**CITY PLANNING COMMISSION**  
1231 "I" STREET, SUITE 200, SACRAMENTO, CA 95814

- APPLICATION:**
- A. Negative Declaration;
  - B. Tentative Map to be called "North Avenue Estates" to divide 6.85± partially developed acres into 35 single family lots and one open space lot in the Standard Single Family (R-1) zone;
  - C. Variance to create lots less than 52 feet wide;
  - D. Variance to create corner lots less than 62 feet wide;
  - E. Subdivision Modification to create lots less than 52 feet wide; and,
  - F. Subdivision Modification to create corner lots less than 62 feet wide.

**LOCATION:** 1519 and 1527 North Avenue

# TENTATIVE SUBDIVISION MAP

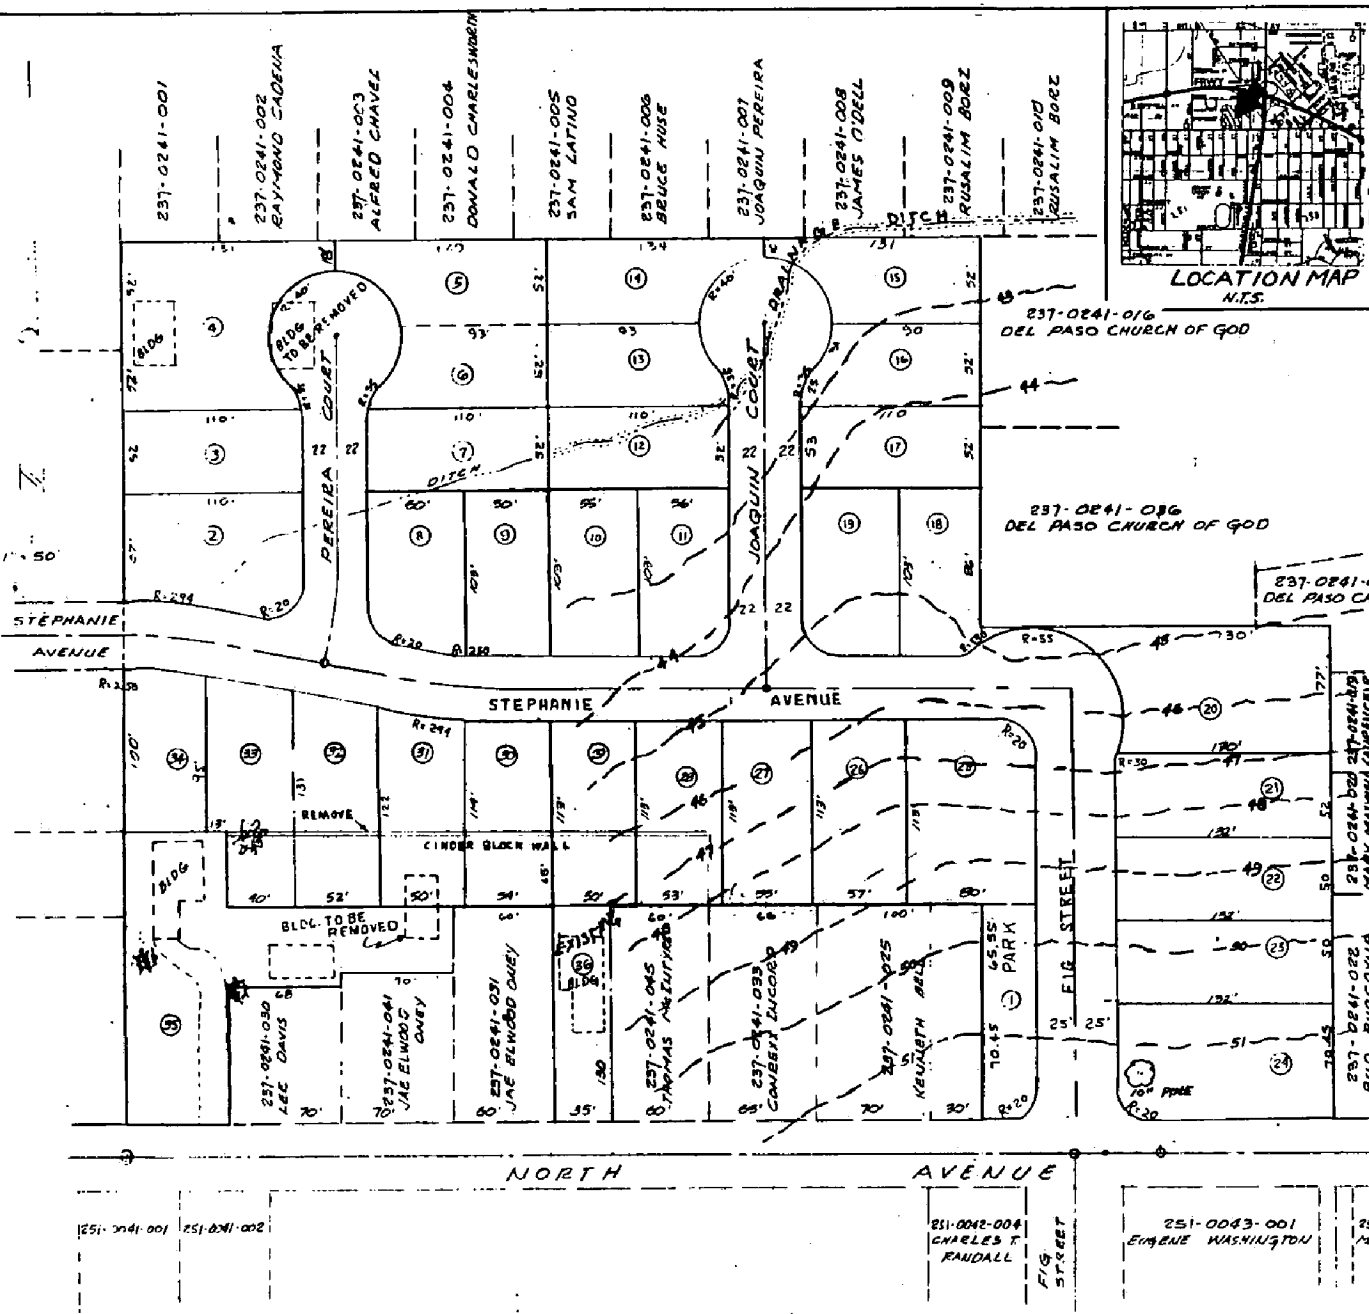
Site Design and Lot Layout- The subdivision would create 35 single family lots. The single family lots primarily range in size from 5200 to 7,000± square feet. Staff finds that the overall design of the map is compatible with the General Plan, zoning and surrounding land uses.

Variances and Subdivision Modifications- Because of the surrounding development, there will be six parcels that have widths of about 50 feet rather than the required 52 feet. Three corner lots will be approximately 60 feet in width rather than the required 62 feet. These parcels require approval of variances and subdivision modifications before they can be created. In addition, there are three other irregular lots; lots #1, #35 and #36. Lot #1 is 32'X 130' and Lot #36 is 35'X 130'. Because of the small size of lot #1, staff is recommending that it be combined with an adjoining lot. Lot #36 is a portion of an existing deep lot. Lot #36 has an existing dwelling on it. Although Lot #36 will be substandard, it is an existing condition that will not be significantly altered by the subdivision. Lot 35 is also irregular in shape as the existing owner desires to retain a storage building located on the site. Staff cannot support the creation of the substandard lot #1. Staff, however, will

support the new boundaries for Lot #35 and #36 as they are already irregular and will not result in any impacts on the surrounding properties.

1. Provide standard subdivision improvements pursuant to Section 40.811 of the City Code;
2. Prepare a sewer and drainage study for the review and approval of the City Engineer; Provide an underground pipe system to intercept the off-site drainage ditch;
3. Pay off existing assessments, or file the necessary segregation requests and fees to segregate existing assessments;
4. Pursuant to City Code Section 40.1302 (parkland dedication), the applicant shall submit to the City an appraisal of the property to be subdivided and pay the required parkland dedication in-lieu fees.

6. Submit a soils test prepared by a registered engineer to be used in street design;
7. Parcel #1 shall be combined with an adjacent parcel to assure continued maintenance responsibility prior to filing of the final map;

8. Remove existing buildings on Lot 4 and Lot 31 and existing cinder block wall on Lots 28 to 33 prior to filing of final map;
9. Dedicate a standard 12.5-foot public utility easement for underground public utility facilities and appurtenances adjacent to all public ways;
